**IECC RESIDENTIAL COMMITTEE ACTION REPORT ON THE RESULTS
ON THE 2022
PUBLIC COMMENTS/CODE CHANGES TO PUBLIC COMMENT DRAFT 1
TO THE INTERNATIONAL ENERGY CONSERVATION CODE-RESIDENTIAL (5/1/23)**

Results of the Residential Consensus Committee Public Comment Draft #1 Process November 2022-April 2023

* R406 ERI "not including OPP" targets in IECC 2024 Public Comment Draft #1

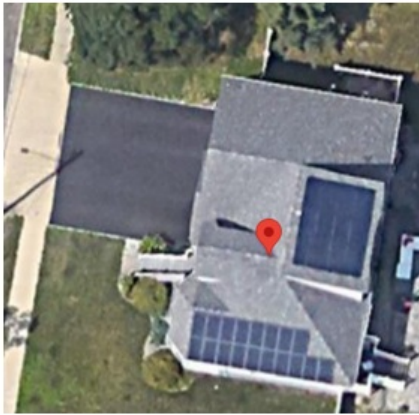
The ERI with OPP targets in Public Comment Draft #1 (40 in every climate zone) were placeholders and not based on any form of analysis. The purpose of this proposal is to update the ERI with OPP targets based on simulation analysis via Residential Energy Services Network (RESNET) Accredited Rating Software (Ekotrope). PNNL analyzed the single-family prototypes (2376 sq ft) in the Ekotrope Rating software across all system types, foundation types and 19 representative cities based on a national scale analysis. According to NAHB, 2021 fourth quarter Census Quarterly Starts show a median single-family home is 2,338 square feet. Using prototype models that meet the ERI without OPP targets in Public Comment Draft #1 as the baseline, PNNL modeled onsite PV systems (1 kW, 2 kW and 4 kW) to calculate ERI with OPP potential targets based on system size. The modeled PV systems were oriented due south and tilted equal to the site latitude. The results are summarized in the table above.

The decision to propose 2 kW ERI with OPP scores for Table R406.5 was based in part on the fact that a 2 kW size system fits almost any rooftop. However, based on LBNL and PNNL research, the median size residential PV system in the U.S. in 2021 was 7 kW, with most systems – those within the 20th to 80th percentile – between 4 and 10 kW.

The proposed ERI with OPP targets represent an easy score for a home to meet utilizing onsite PV.
